**DEMOLITION FLOOR PLAN - BUILDINGS R5 & R6**

**HORT SCHOOL MODERNIZATION BAKERSFIELD CITY SCHOOL DISTRICT**

**FLOOR PLAN BUILDINGS R5 & R6**

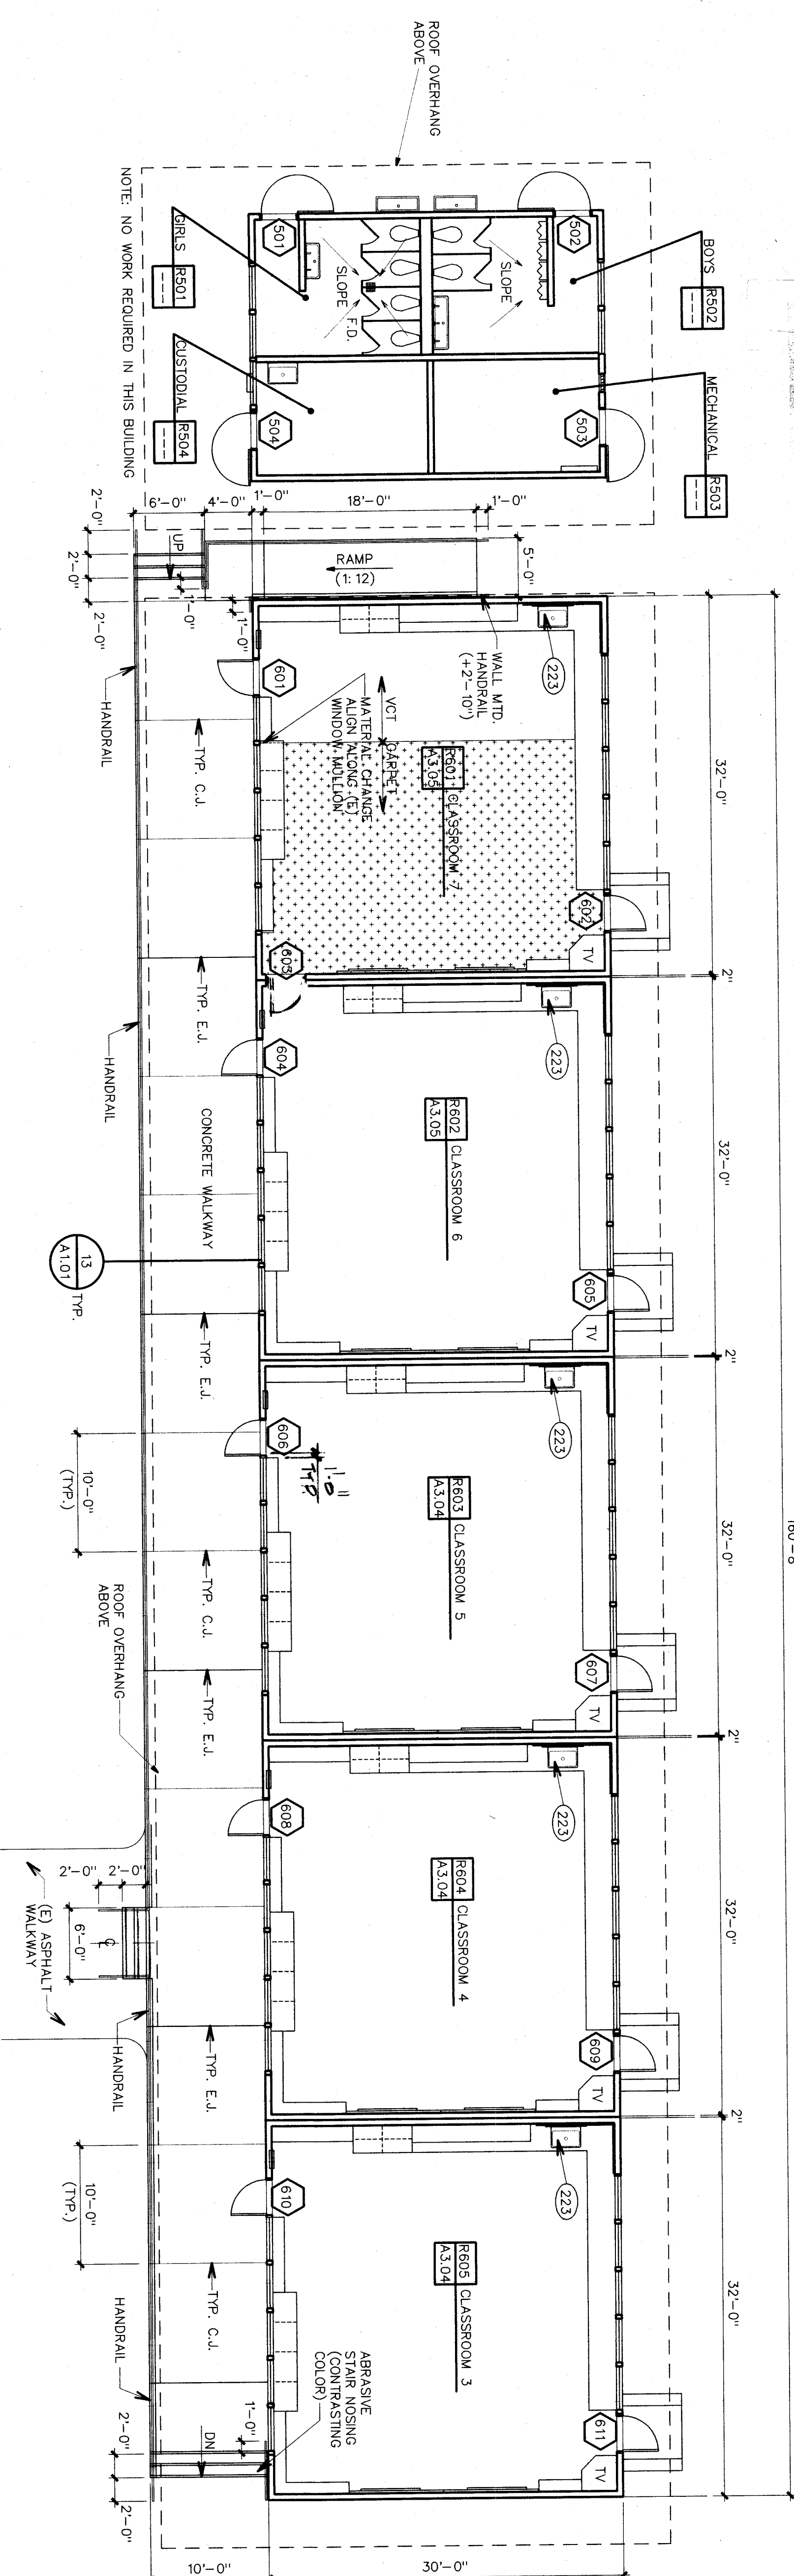
Item 1 (b) Refer to Architectural Drawings, Sheets A2.04 and A2.05  
 R5 and R6  
 a. REMOVE existing wood door sill for exterior doors in Buildings R5 and R6 and  
 REPLACE with threshold specified in Specification Section 08710.  
 b. Contractor shall paint window frames in Buildings R5 and R6.  
 160'-8"
